**Subject** Tipping Building Ventilation Mechanical Options, Response to Comments  
**Attention** Alfredo Arroyo/PSCAA  
**From** Stacia Dugan/Jacobs  
**Date** November 9, 2018  
**Copies to** Cedar Grove Composting, Inc.

Puget Sound Clean Air Agency (PSCAA) reviewed the mechanical options Cedar Grove has investigated to assist the current building control/ventilation system as provided in the document, "Cedar Grove Composting, Inc. Tipping Building Ventilation Review," dated December 18, 2017. Based on the review, PSCAA has developed the following list of questions/comments, which are presented in **Bold** below. Below each question, Cedar Grove and Jacobs have provided responses.

**Figure 2. Tipping Building Biofilter Intake**

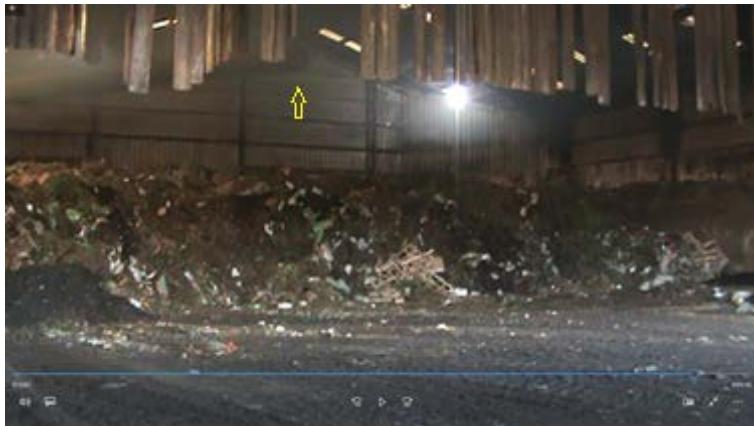
- 2) **The first sentence of Paragraph 3 in Page 2 of the review states that “In 2012, the tipping building had a continuous exhaust ventilation system with the exhaust point located near the peak of the interior south wall.” Is the current exhaust point location and size the same as in 2012? Please provide a diagram of the south wall verifying the information.**

The tipping building intake that sends air to the tipping biofilter was not moved and is in the same position it was in before 2012. The fan is also the same fan as was in place before 2012. However, as stated in the document, the tipping biofilter was redesigned to allow for increasing the size of the biofilter by about 23 percent, therefore increasing the residence time in the biofilter. The 23 percent increase was the most Cedar Grove could do because of restrictions created by truck traffic and storm water drainage flow. Figure 2 is a picture of the tipping biofilter intake.

**Figure 4. Velocity Contours and Streamlines for Flanged Hood**

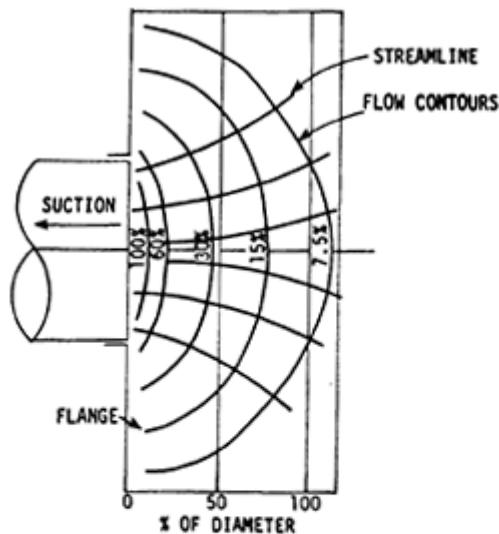
- 3) The first two sentences of Paragraph 4 in Page 4 of the review states that “It is important to understand that the intake behaves like a vacuum. If you put your hand right in front of the vacuum, the pull is strong, but as you move your hand farther away the pull diminishes.” The tipping building’s set of bay doors are located on the wall opposite the south wall where the only exhaust point (of tipping building) and intake into the biofilter is located. The statements documented by Jacobs hypothesize that the pull or vacuum per minute at any open tipping building bay door is less than that at or near the exhaust point. When designing the tipping building’s ventilation system, did Cedar Grove verify that the design pull or vacuum per minute “at or near” any open tipping building bay door would exceed the natural ventilation rate to the outdoors? Please provide the engineering analysis confirming the design. By “at or near” I mean the area that the natural ventilation rate can potentially exceed the pull or vacuum of the biofilter’s ventilation system. During smoke tests, smoke has been observed to escape (the amount is irrelevant from a permitting standpoint), therefore, showing that the pull

or vacuum per minute at or near an open tipping building bay door is not enough to overcome the natural ventilation rate of the building.

EPA's Performance Evaluation Guide for Large Flow Ventilation systems, EPA-340/1-84-012, Figures 4 and 5 indicate how airflow velocity diminish as you move away from the ventilation intake.

The figure demonstrates that the air velocity decreases as you move away from the face of the intake, but the volume of air being moved increases. This is the reason the smoke does not appear to go directly into the intake and the reason why the smoke moves in a swirling pattern though the building as air moves to replace the air going into the intake. However, we can still use the airflow at the intake to estimate the airflow at the open doorway. The total volume of air being sent to the biofilter is being replaced by the air coming in through the doorway. This volumetric airflow can be used to estimate the average air flow velocity through the doorway.
